TECHNICAL INFORMATION

Date: 14.02.2023
TI: 0323
Type of vending machine: HG/HO Espresso Variants

New temperature sensor for 2.0 kW and 2.7 kW boilers

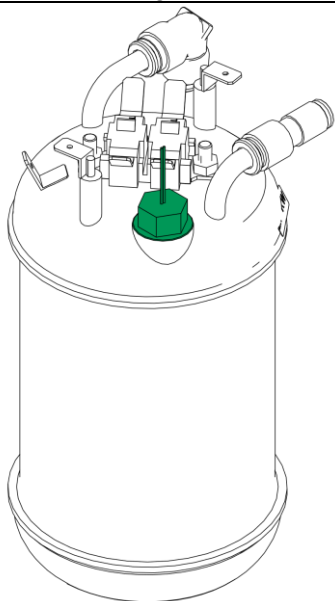
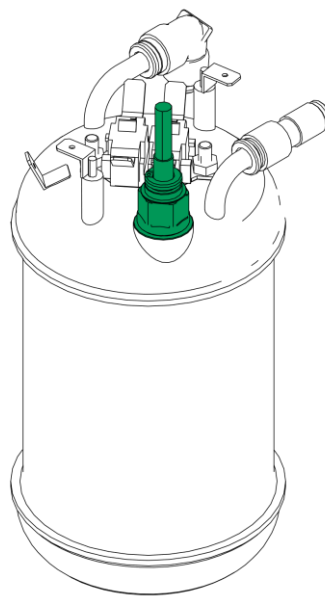
The screwed temperature sensor of the espresso boiler is no longer available. Therefore, from **production week 50/2022** with **serial number 90538625**, a screw-in fitting with quick coupling with a plugged-in temperature sensor will be used.

The temperature sensor has identical performance characteristics as the original sensor.

Previous boiler with temperature sensor with integrated screw-in fitting

New boiler with temperature sensor for screw-in fitting

For spare parts, the temperature sensor set-up kit with item number 420 50 140 00 must be ordered in future. In addition to the screw-in fitting and the temperature sensor, this also includes detailed assembly instructions.
